RFI #: 13
Date: 5/12/2008
Job: 07-20-2046 Hoosic Valley Central School
Phone:

Subject: HV01-7 - Catch Basin Specifications

Drawing: HS C-106 - Athletic Field Stormwater and
Water Main Plan

PROJECT No.
2540702
 DRAWING No.
C-SK-3

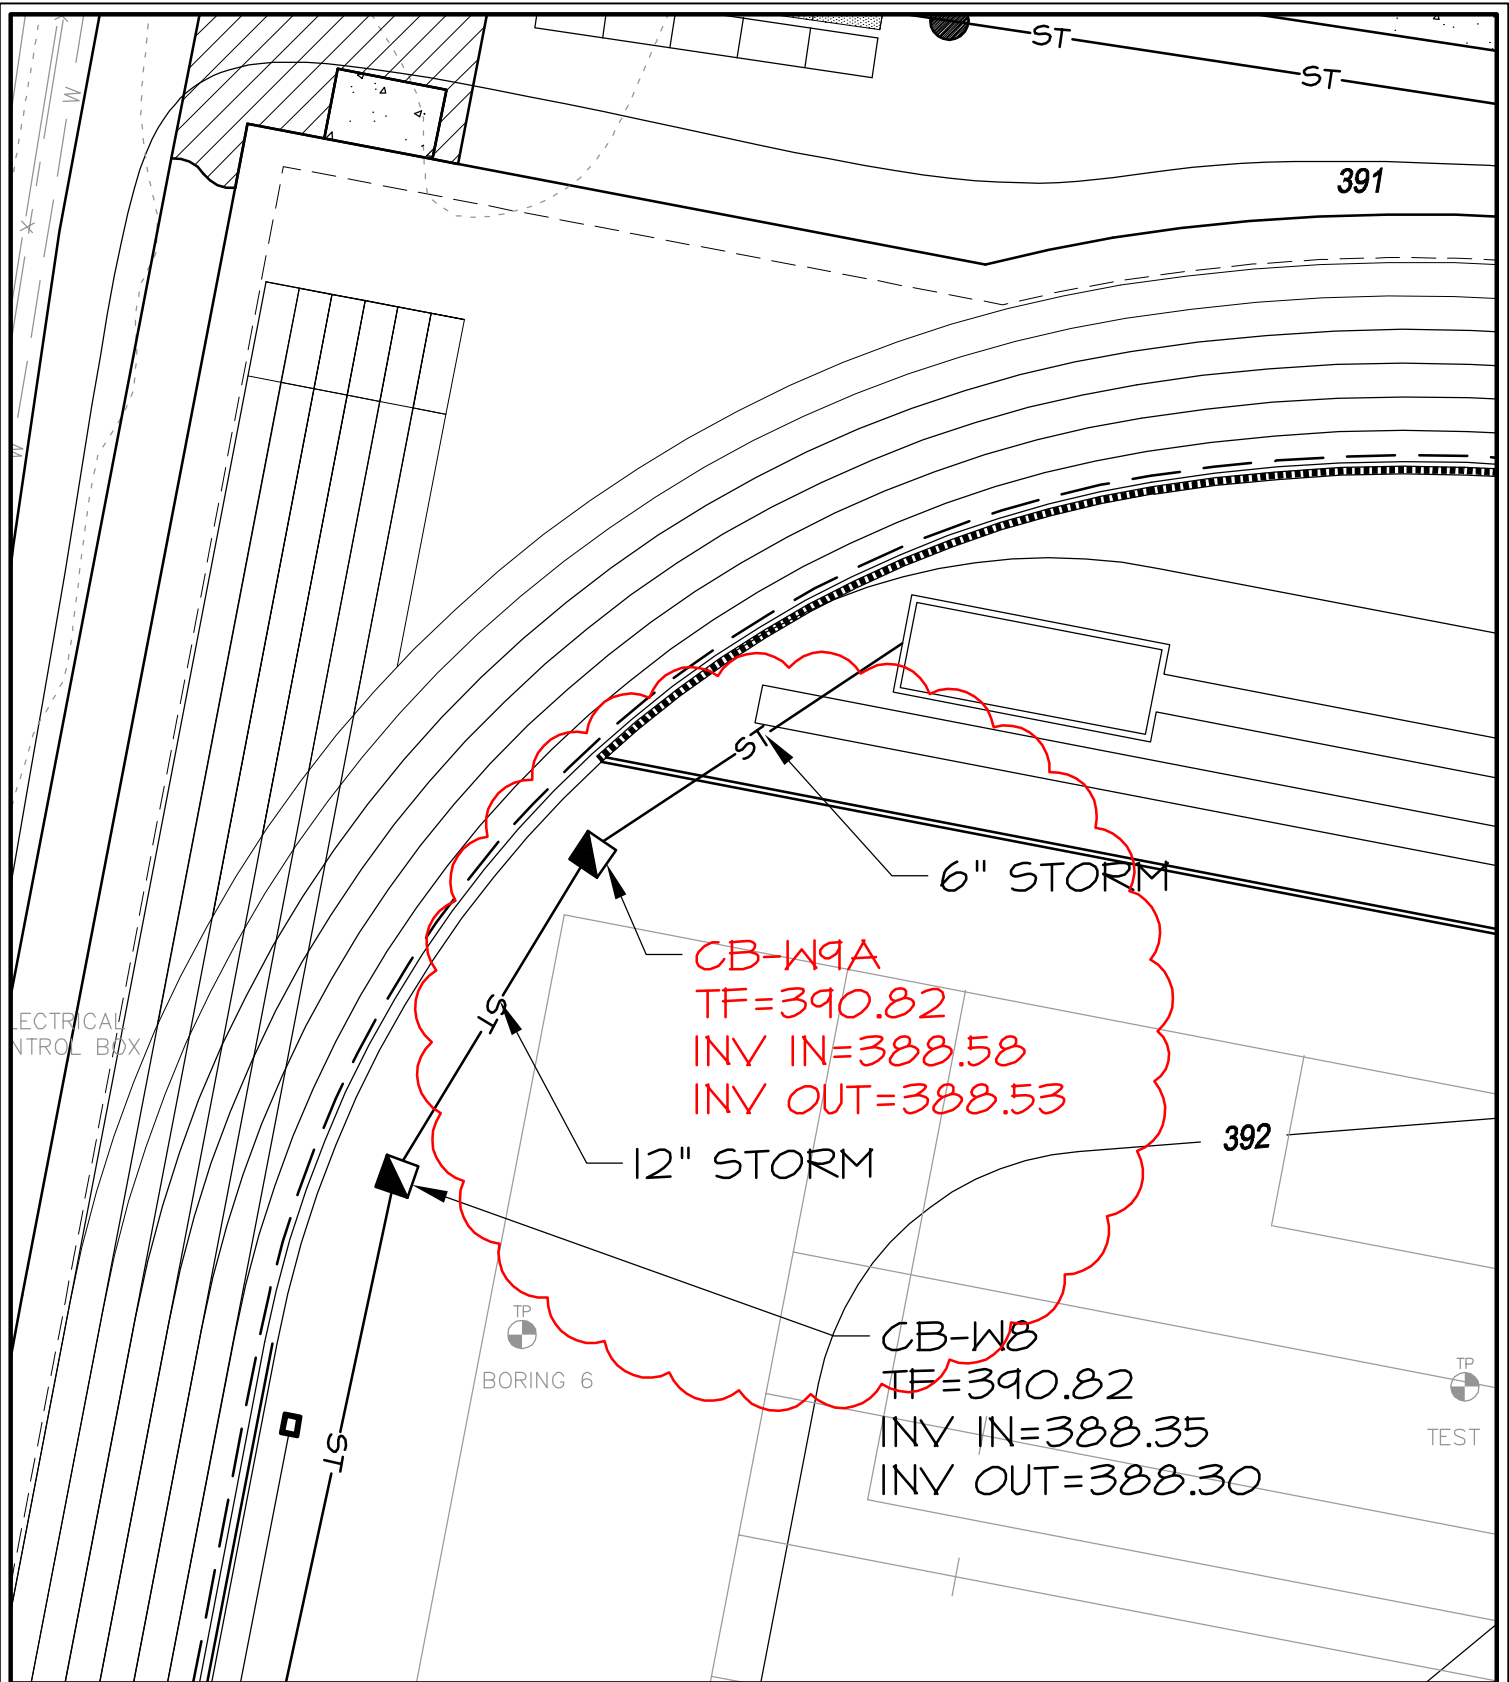
Request: **Date Required: 5/16/2008**
Dwg HS C-106; Field A NW corner CB between W8 and long jump pit. Please provide ID, rim, pipe sizes and inverts.

Response:
See Attached Drawing C-SK-3.
